Proposed Motorway Rest Area
M4 Junction 16, Swindon, Wiltshire

Forecasting Report

M4 Junction 16 VISSIM Modelling

**STAGE 1 - ROAD SAFETY AUDIT
SEPTEMBER 2025**

DRAWING NUMBER:	3728-F13	REVISION:	H
-----------------	----------	-----------	---

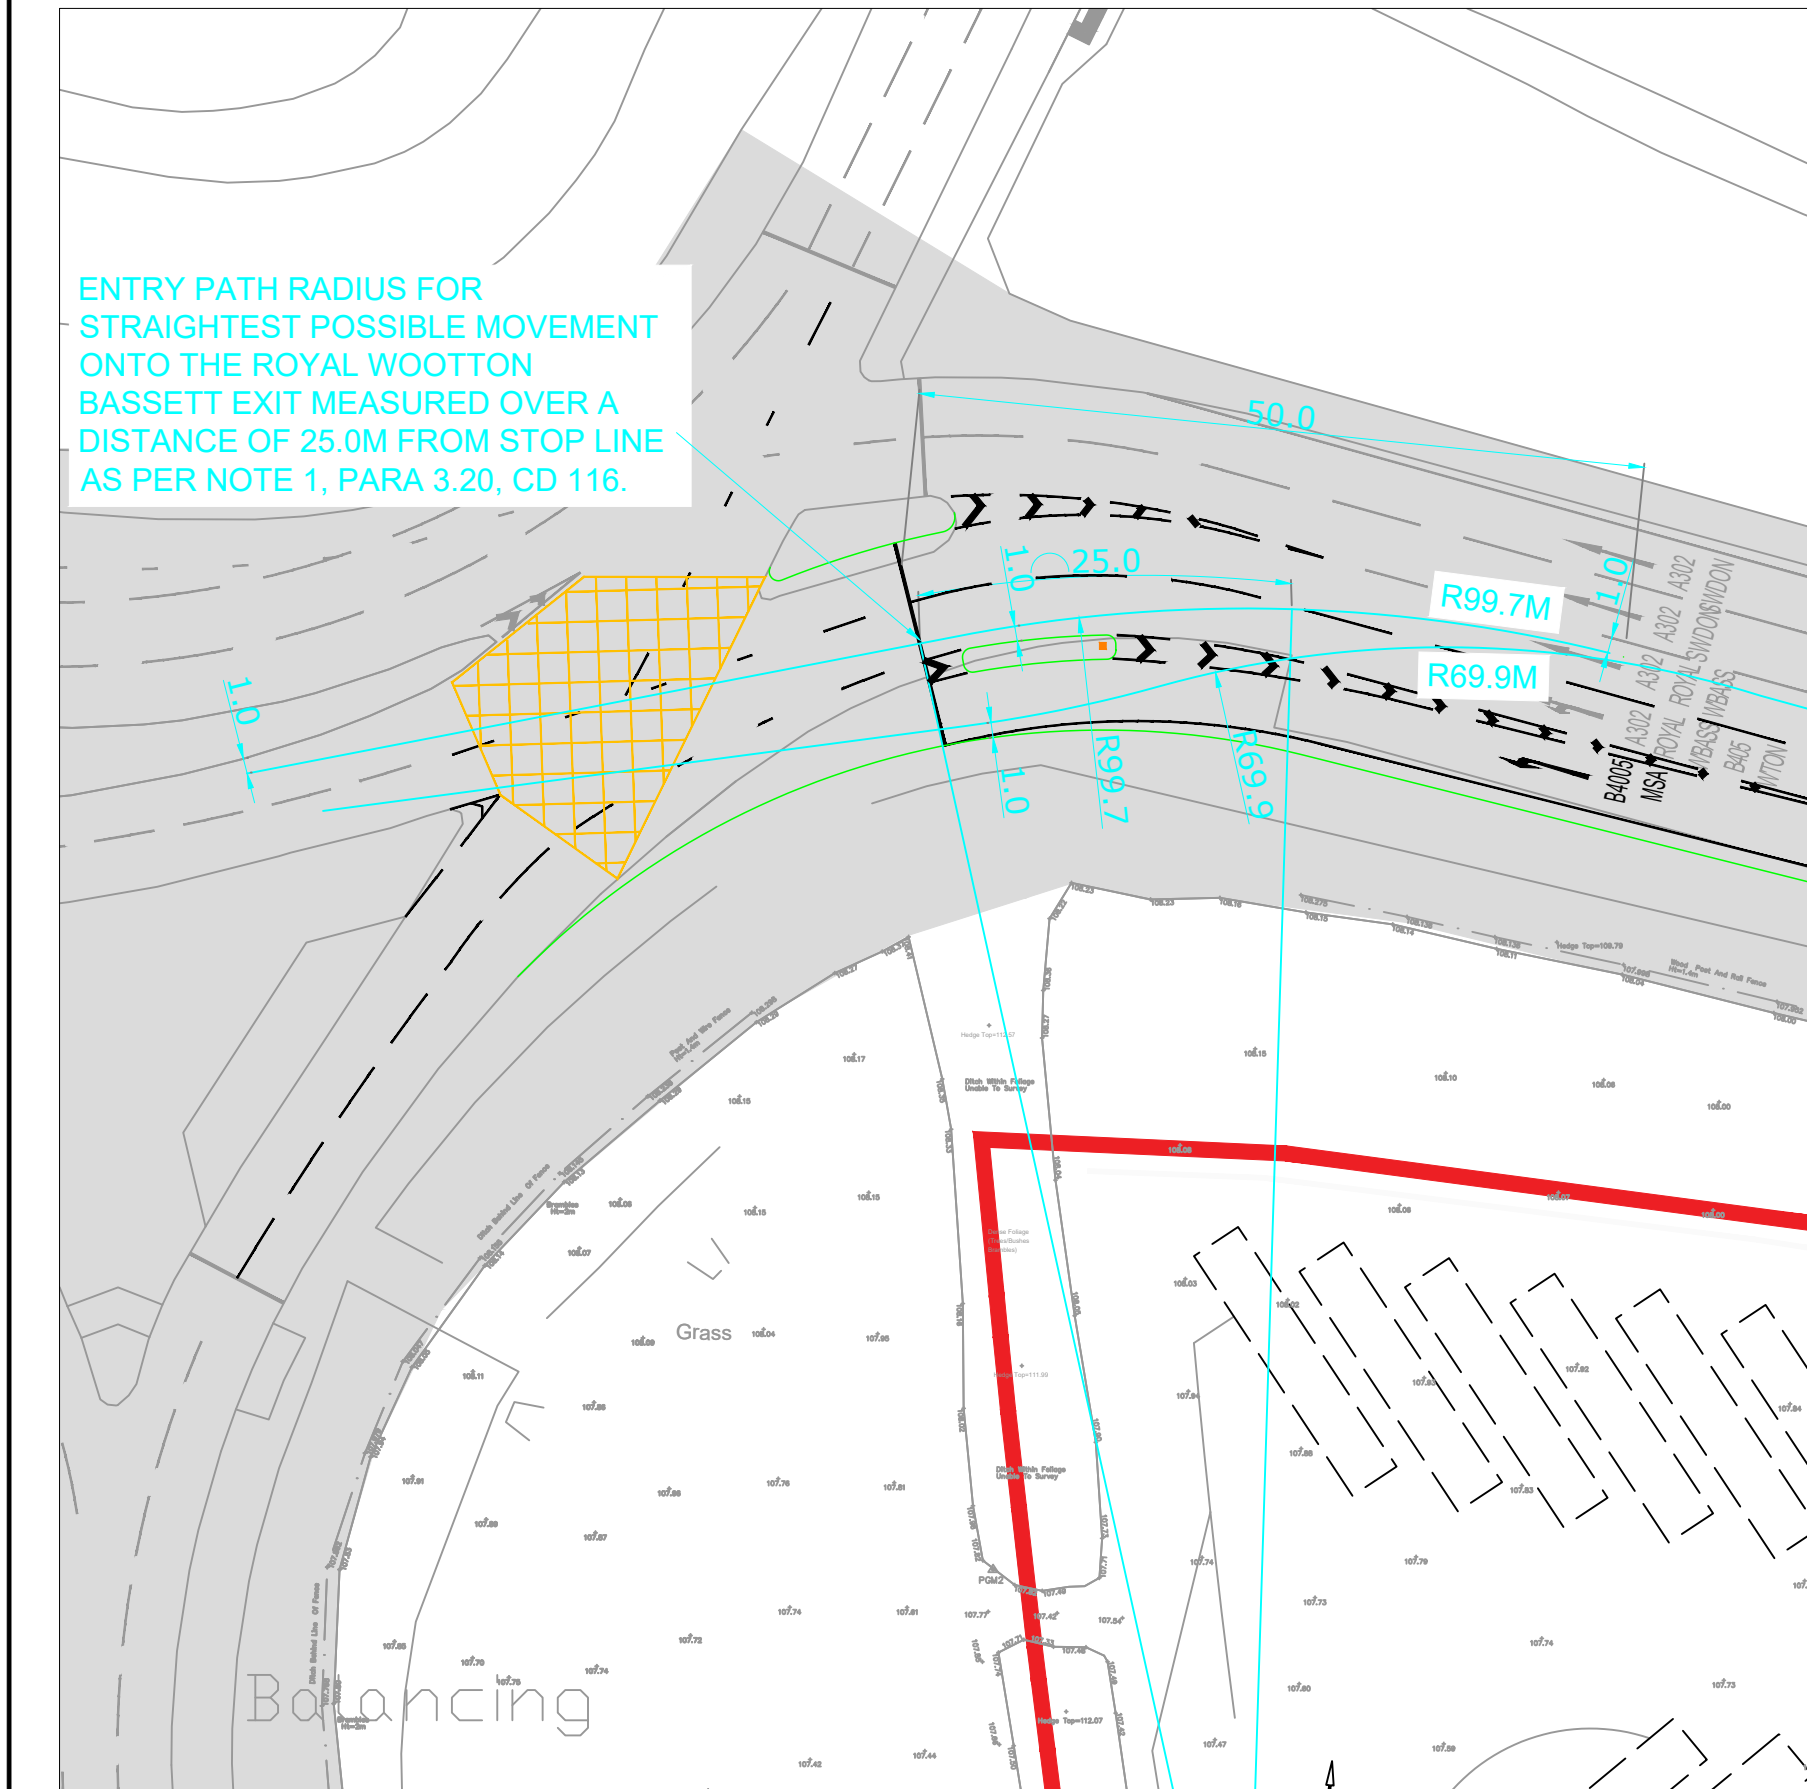
- 2.1 The scheme drawings indicate that revisions will only be made to the westernmost nearside lane destination sign. Omission of changes to the other relevant lane destination signage on the slip road or on the Advanced Directional Sign (ADS) on the M4 mainline in advance of the slip road may result in drivers being provided with insufficient advance warning as to which lane they need to be in to access the services, which could result in injudicious late lane changes that could increase the risk of side swipe type collisions.

Location of Identified Problems

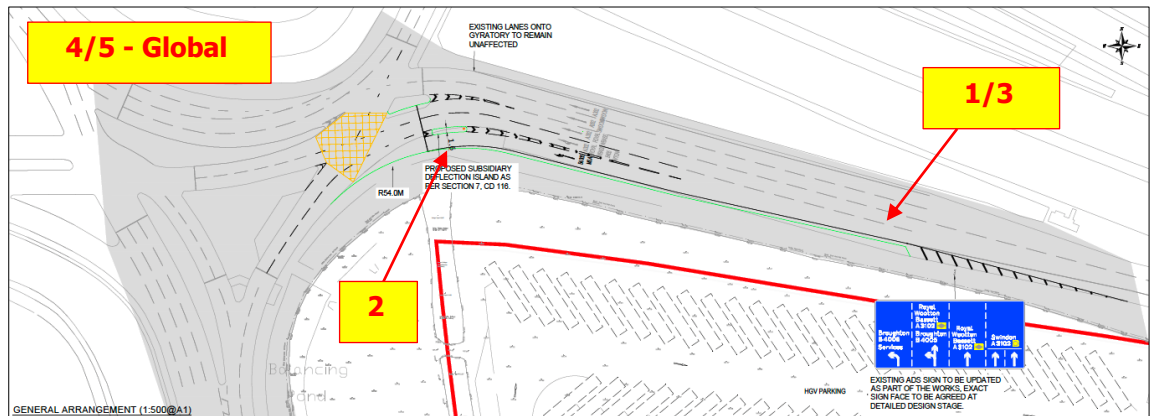
PROBLEM 1

LOCATION: M4 Junction 16 westbound off-slip.

SUMMARY: Omission of sufficient signage provision may increase the risk of side swipe type collisions.

- 2.2 It is recommended that revisions to all the pertinent ADS and lane destination signage be undertaken and this information be provided for review at the Stage 2 RSA.

PROBLEM 2

SUMMARY: Implications on Vehicle Restraint System (VRS) may result in an increased risk of higher severity outcomes should collisions occur.

- 2.3 The proposed highways works are likely to require alterations to the existing (VRS) on the southern side of the slip road, which may have implications on the level of containment which could affect the severity of outcomes of any collisions involving errant vehicles.

- 2.4 It is recommended that an assessment of the changes to the VRS be undertaken and if considered relevant to highway safety, mitigation measures be implemented.

PROBLEM 3

SUMMARY: Potentially excessive vehicle queues could increase the risk of rear-end shunt type collisions.

- 2.5 The audit brief indicates that the proposed development will increase the volume of vehicles using the slip road and turning left at the Spitalborough Roundabout onto the B4005. However, no junction capacity assessments have been provided for review and therefore it is unclear if there is sufficient capacity to accommodate the forecast additional volume of

- 2.6 It is recommended that junction capacity assessments be undertaken and mitigation be undertaken if the forecast levels of queuing would impact on the running of the M4 westbound mainline.

PROBLEM 4

SUMMARY: Potential for increased risk of vehicle collisions due to omission of signage.

- 2.7 The audit brief does not provide any details of what if any signage provision etc is proposed for drivers accessing the facility via the M4 Junction 16 eastbound off-slip. The potential omission of suitable signage etc could increase the risk of collisions on the M4 Junction 16 eastbound off-slip or on the circulatory carriageway of the roundabout due to for example driver confusion as to which lane they should be in if accessing the MSA and making injudicious manoeuvres which could result in side swipe type collisions.
- 2.8 The audit team note that this matter is outside the geographical scope of the scheme presented for audit, but is directly related to the proposals and may have road safety implications.

- 2.9 It is recommended that appropriate signage etc be provided for drivers accessing the MSA via the M4 Junction 16 eastbound off-slip.

PROBLEM 5

SUMMARY: Potentially excessive vehicle queues could increase the risk of rear-end shunt type collisions.

- 2.10 The audit brief does not provide any information with regard to the potential increase in traffic movements resulting from the proposed development that will access the MSA facility via the M4 Junction 16 eastbound off-slip nor any junction capacity assessments resulting from increased vehicle movements. It is unclear therefore if there is sufficient capacity to accommodate any additional volume of development traffic without potentially resulting in excessive queuing, which could impact vehicles travelling on the M4 east bound mainline which could increase the risk of rear end shunt type collisions.

- 2.12 It is recommended that junction capacity assessments be undertaken and mitigation be undertaken if the forecast levels of queuing would impact on the running of the M4 eastbound mainline/ roundabout circulatory carriageway.

RSA problem	RSA recommendation	Design organisation response	Overseeing Organisation response	Agreed RSA action
Problem 1: Omission of sufficient signage provision may increase the risk of side swipe type collisions. The scheme drawings indicate that revisions will only be made to the westernmost nearside lane destination sign. Omission of changes to the other relevant lane destination signage on the slip road or on the Advanced Directional Sign (ADS) on the M4 mainline in advance of the slip road may result in drivers being provided with insufficient advance warning as to which lane they need to be in to access the services, which could result in injudicious late lane changes that could increase the risk of side swipe type collisions.	It is recommended that revisions to all the pertinent ADS and lane destination signage be undertaken and this information be provided for review at the Stage 2 RSA.	RSA problem and recommendation accepted by the design organisation. As part of the detailed design stage existing ADS and lane changing signage will be reviewed as part of the signage proposals for the scheme. This will also include the proposals for new signage too.	Response accepted	To be addressed at detailed design

Problem 2: Implications on Vehicle Restraint System (VRS) may result in an increased risk of higher severity outcomes should collisions occur. The proposed highways works are likely to require alterations to the existing (VRS) on the southern side of the slip road, which may have implications on the level of containment which could affect the severity of outcomes of any collisions involving errant vehicles.	It is recommended that an assessment of the changes to the VRS be undertaken and if considered relevant to highway safety, mitigation measures be implemented.	RSA problem and recommendation accepted by the design organisation. As part of the detailed design stage a RRRAP is to be undertaken to confirm the VRS requirements following the modification to the existing alignment of the VRS barrier. VRS proposals to be provided for approval.	Response accepted	To be addressed at detailed design

Problem 3: Potentially excessive vehicle queues could increase the risk of rear-end shunt type collisions. The audit brief indicates that the proposed development will increase the volume of vehicles using the slip road and turning left at the Spittalborough Roundabout onto the B4005. However, no junction capacity assessments have been provided for review and therefore it is unclear if there is sufficient capacity to accommodate the forecast additional volume of development traffic without potentially resulting in excessive queuing, which could impact vehicles travelling on the M4 westbound mainline which could increase the risk of rear end shunt type collisions.	It is recommended that junction capacity assessments be undertaken and mitigation be undertaken if the forecast levels of queuing would impact on the running of the M4 westbound mainline.	RSA problem and recommendation accepted by the design organisation. Junction capacity assessments have been undertaken and are currently with National Highways for their review. Full junction capacity details can be provided upon agreement of the junction modelling with National Highways, prior to Stage 2.	Response accepted	Modelling results to be provided for Stage 2 audit

Problem 4: Potential for increased risk of vehicle collisions due to omission of signage. The audit brief does not provide any details of what if any signage provision etc is proposed for drivers accessing the facility via the M4 Junction 16 eastbound off-slip. The potential omission of suitable signage etc could increase the risk of collisions on the M4 Junction 16 eastbound off-slip or on the	It is recommended that appropriate signage etc be provided for drivers accessing the MSA via the M4 Junction 16 eastbound off-slip.	RSA problem and recommendation accepted by the design organisation. As part of the detailed design stage new signage for the motorway service area will be provided for approval. Signs will be in accordance with Guide to the signing of roadside facilities for motorists on the strategic	Response accepted	To be addressed at detailed design

circulatory carriageway of the roundabout due to for example driver confusion as to which lane they should be in if accessing the MSA and making injudicious manoeuvres which could result in side swipe type collisions. The audit team note that this matter is outside the geographical scope of the scheme presented for audit, but is directly related to the proposals and may have road safety implications.		road network in England'.		
Problem 5: Potentially excessive vehicle queues could increase the risk of rear-end shunt type collisions. The audit brief does not provide any information with regard to the potential increase in traffic movements resulting from the proposed development that will access the MSA facility via the M4 Junction 16 eastbound off-slip nor any junction capacity assessments resulting from increased vehicle movements. it is unclear therefore if there is sufficient capacity to accommodate any additional volume of development traffic without potentially resulting in excessive queuing, which could impact vehicles travelling on the M4 east bound mainline which could increase the risk of rear end shunt type collisions. The audit team note that this matter is outside the geographical scope of the scheme presented for audit, but is directly related to the proposals and may have road safety implications.	It is recommended that junction capacity assessments be undertaken and mitigation be undertaken if the forecast levels of queuing would impact on the running of the M4 eastbound mainline/roundabout circulatory carriageway.	RSA problem and recommendation accepted by the design organisation. Junction capacity assessments have been undertaken and are currently with National Highways for their review. Full junction capacity details can be provided upon agreement of the junction modelling with National Highways, prior to Stage 2.	Response accepted.	Modelling results to be provided for Stage 2 Audit
